EARLY DESIGN GUIDANCE 2

2203 23rd Ave S.
Seattle, WA, 98144

3034772-EG

Design Review 11.24.2020

PREFERRED RESIDENTIAL LOBBY LOCATION

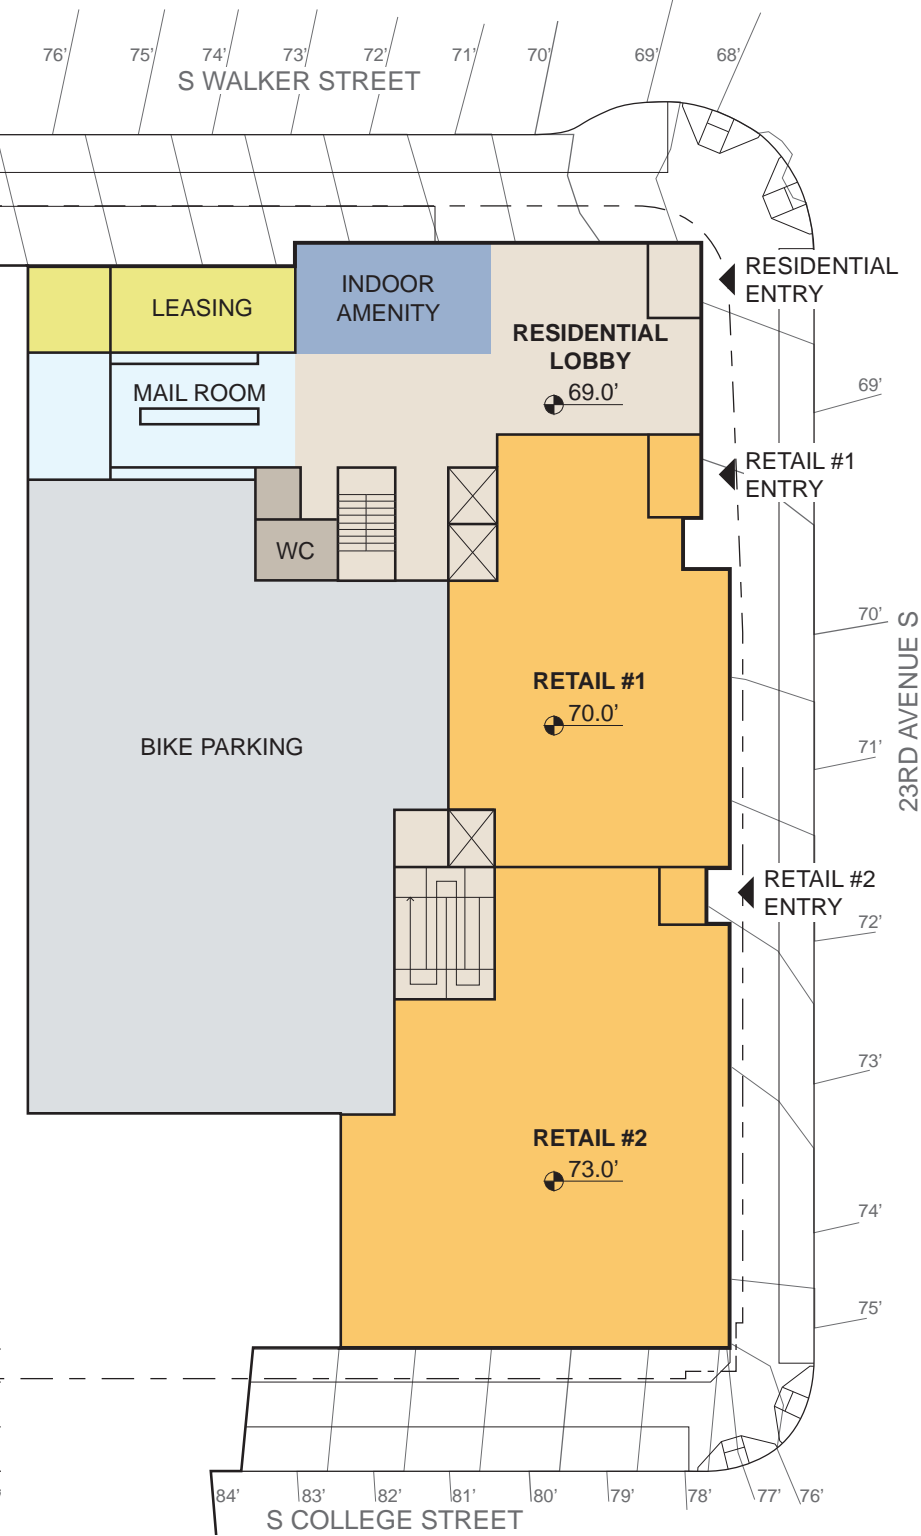
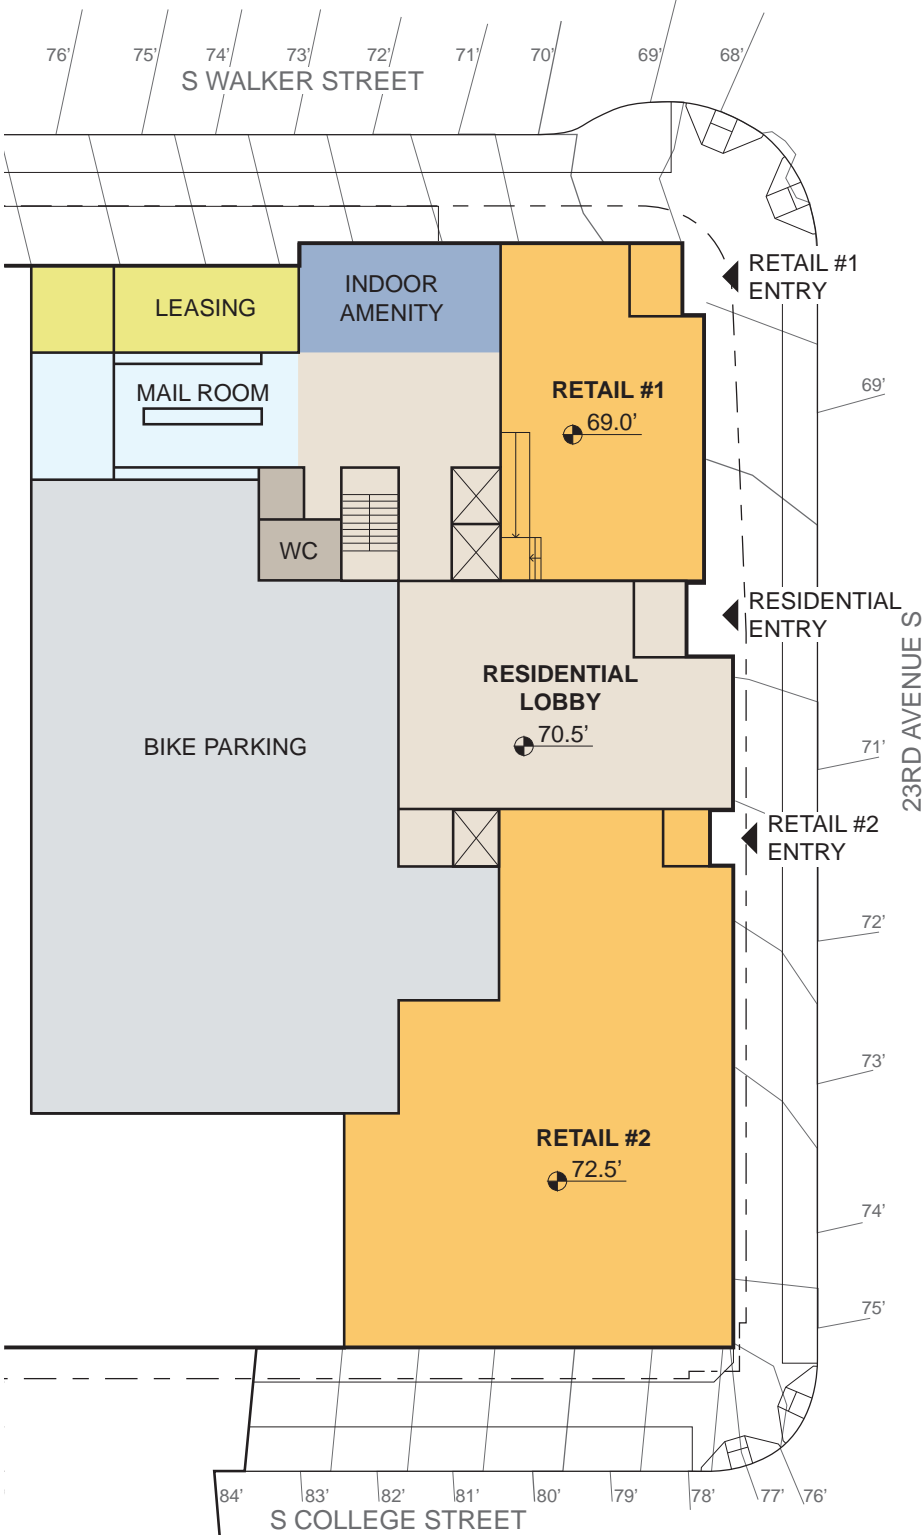
While staff supports the massing of Option 3 Alternate and acknowledges public comment regarding entries, the primary residential lobby at the site’s northeast corner needs to be relocated south. The street level uses on level 1 along 23rd Avenue South need to change to reflect the Level 1 uses and locations shown in Option 2. In Option 2 the residential lobby is located centrally along 23rd Avenue South with commercial spaces north and south of the lobby. The commercial space on the northeast corner of the site wraps the corner and provides commercial space facing South Walker Street. (PL3.A, PL3.C)

Introduce façade modulation on the street level uses to help differentiate the residential lobby and commercial spaces from one another. The current floor plans for staff’s preferred massing generally lack this design detail. (CS2.C.3, PL3.A)

Recesses along the east facade help break up the length of the ground-level storefront and help delineate entryways for retail and the residential lobby. Further studies of the storefront design have been explored to help modulate the facade and provide a human-scaled pedestrian environment along 23rd Avenue S. Refer to sheet 29 for more information.

EDG2 REVISED PREFERRED OPTION 3

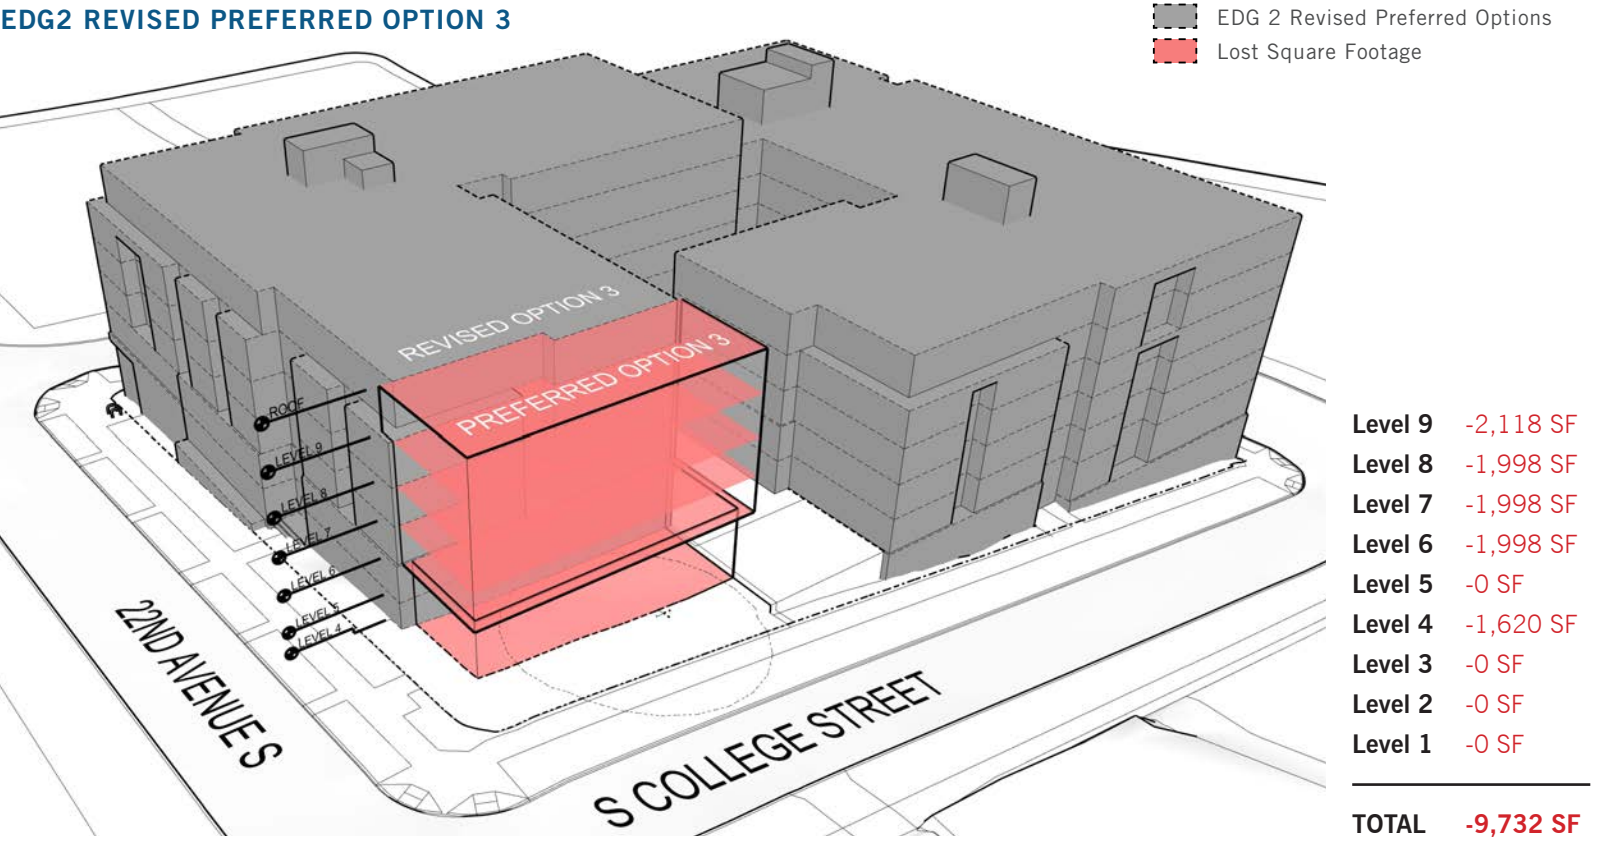
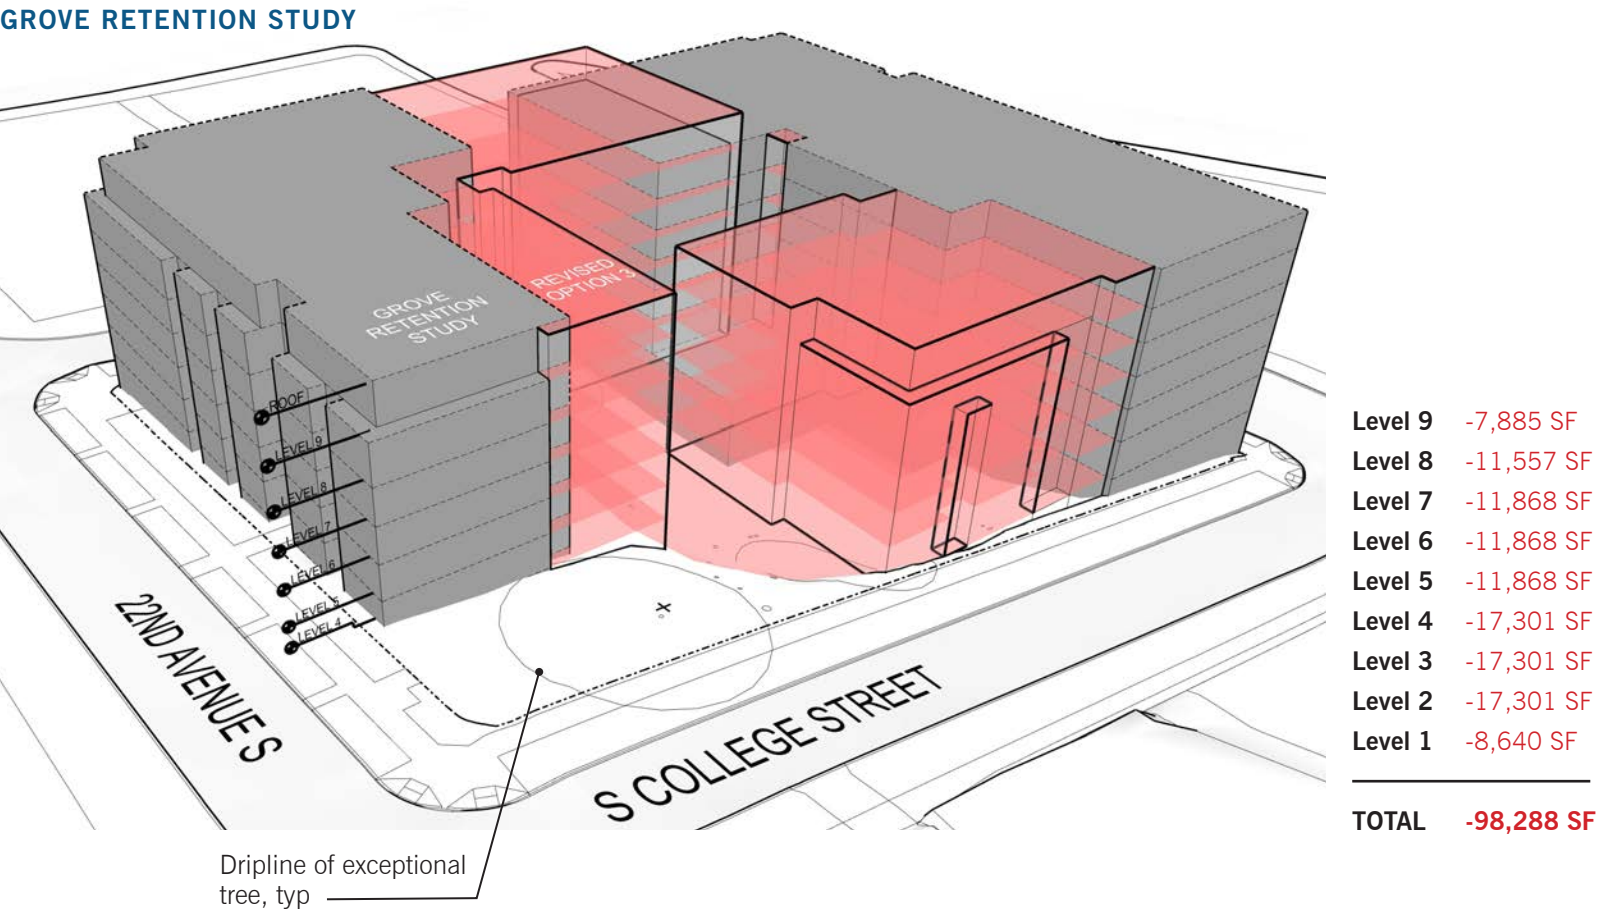
Trees 134 and 116 of the Tree Survey are both located on slopes which would put them generally below the finished sidewalk grade. Of these two trees, tree 134 is located on a steep slope that staff recognizes could create potential challenges with the project’s development and providing usable open space. Staff recommends the next design review packet provide two design alternatives, one that maintains all three trees and the other that retains either one or two of the exceptional trees. The alternative showing one or two trees to remain must include information on the health of the trees to remain and be removed. Removal of the tree or trees would be considered by staff if a design with removal of the tree(s) provides a better design response to Design Guidelines with regard to the topography of the site. Include a study that illustrates why one or more of the exceptional trees cannot be retained even with one or more departure requests in accordance with SMC 25.11.080. (CS1.C, CS1.D)

The upper diagram shows a loss of 9,732 SF compared to Preferred Option 3. Through reconfiguration and additional massing changes, we are able to add back 6,116 SF, resulting in a net loss of 3,616 SF and 9 units.

The lower diagram shows a loss of 98,288 SF compared to Revised Preferred Option 3. Due to the grove trees' location in the middle of the site, the building mass is split into two separate buildings which greatly decreases each building's efficiency as well as the opportunity to include below-grade parking in the design. Furthermore, outdoor amenity that was proposed on level 4 must be relocated elsewhere which further disrupts the efficiency of the Revised Preferred Options 3's form.

The applicant would like to seek Director approval to remove the significant trees and the removal of all grove trees.
